Modification 2 of Westlink Industrial Estate Stage 1

State Significant Development Modification Assessment Report (SSD-9138102-Mod-2)

July 2024

Figure 3 | Modified Site Layout

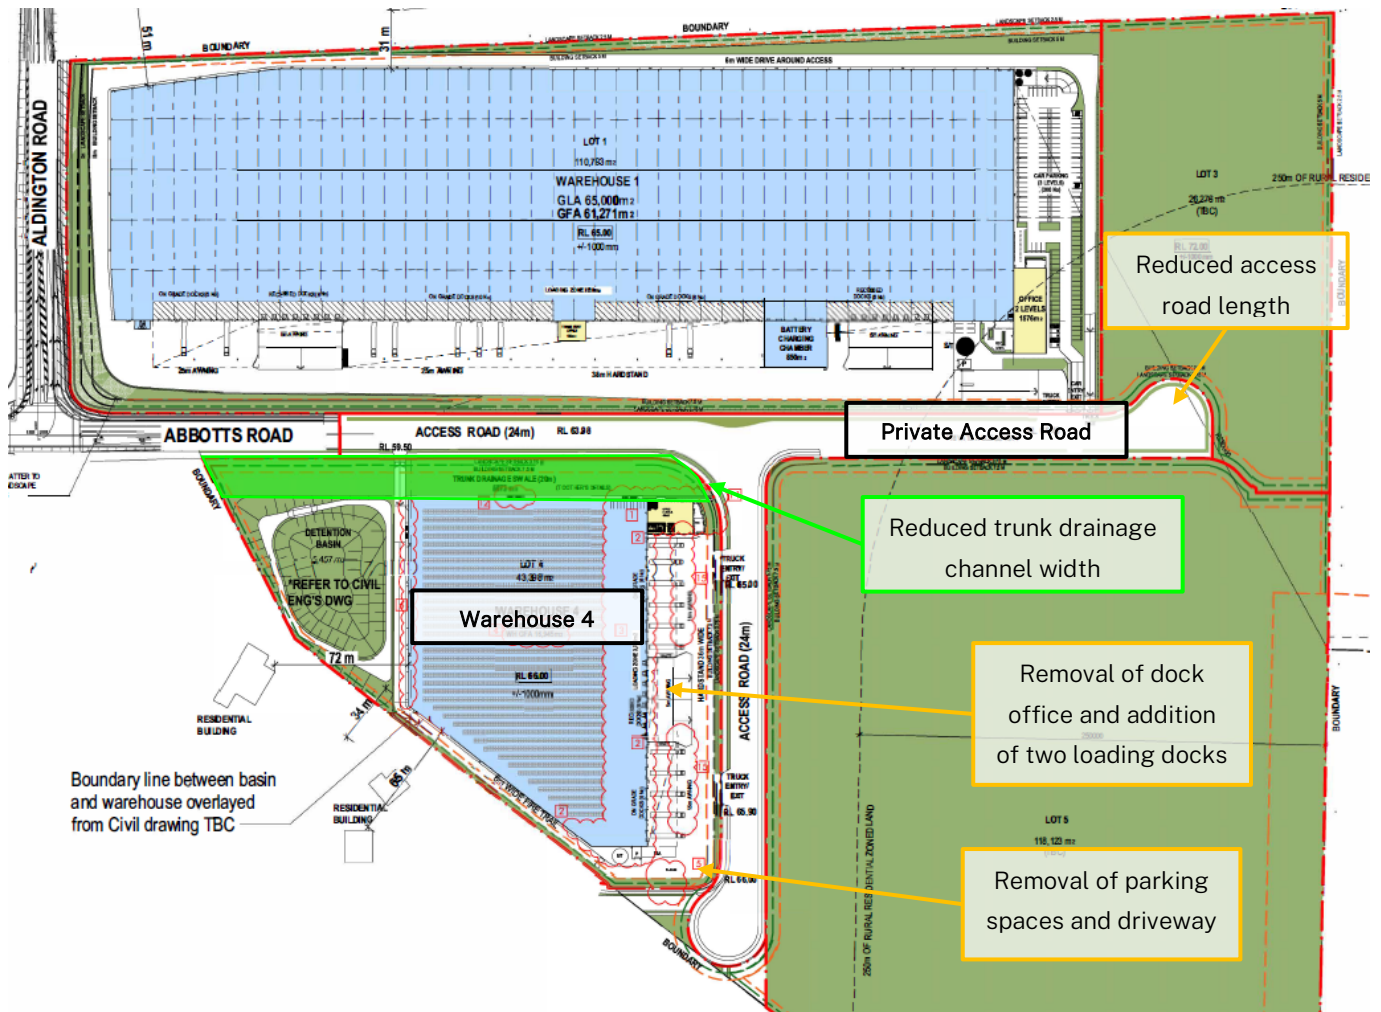
Project Element	Proposed Modification
Trunk drainage channel	Reduction in width from 25m to 20m to reflect the design endorsed by Sydney Water (under Condition B28 of the consent).
Warehouse 4 design changes	<ul style="list-style-type: none"> • Extension of building footprint northwards commensurate with reduced channel width • Extension of warehouse 4m eastward, reducing hardstand width and shifting office 4m east • Southern warehouse wall moved south • Increase in loading zone area from 1,470m² to 4,035m² • Reduction in total gross floor area from 17,460m² to 17,425m² • Removal of the loading dock office • Addition of warehouse amenities • Increase in number of loading docks from 17 to 19 • Reduction of width of loading dock awning to 15m • Change to undercoft car park egress design to meet Building Code of Australia (BCA) requirements, amendment to floor gradient and addition of two parking spaces • Removal of car parking spaces and access driveway at southern end of Lot 4 • Reduction in total car parking spaces from 96 to 85 • Amendments to office layout.

Stormwater infrastructure	Modification to the on-site detention (OSD) basin design to align with narrowed trunk drainage channel
Private access road	Reduced length of road between Lots 1, 3 and 5 and changes to the cul-de-sac orientation and associated earthworks.
